Model: PALM-B (D567, PB1030)		Date: 15-Jun-11	No.: RD567001
Subject: Plate: Heat Sink: 1		Prepared by: M. Ishihara	
From: 2 nd Overseas Tech Support Sec. 2 nd PQM Dept.			
Classification:	<input type="checkbox"/> Troubleshooting <input type="checkbox"/> Mechanical <input type="checkbox"/> Paper path <input type="checkbox"/> Product Safety	<input checked="" type="checkbox"/> Part information <input type="checkbox"/> Electrical <input type="checkbox"/> Transmit/receive <input type="checkbox"/> Other ()	<input type="checkbox"/> Action required <input type="checkbox"/> Service manual revision <input type="checkbox"/> Retrofit information <input type="checkbox"/> Tier 2

D5672744 (Plate: Heat Sink: 1)

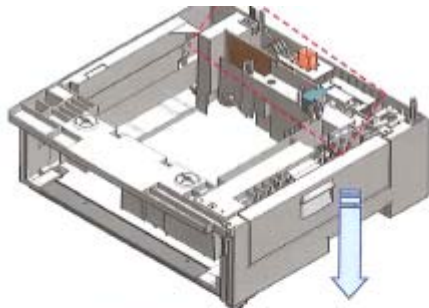
Reason / Change: To prevent temperature increasing when the optional heater is installed, 2 plates were newly added as shown below.

Old P/N	New P/N	Description	Q'ty	Int	Page	Index	Note
-	D5672744	Plate: Heat Sink: 1	0-1	-	3	14	New Index
-	D5672745	Plate: Heat Sink: 2	0-1	-	3	15	New Index
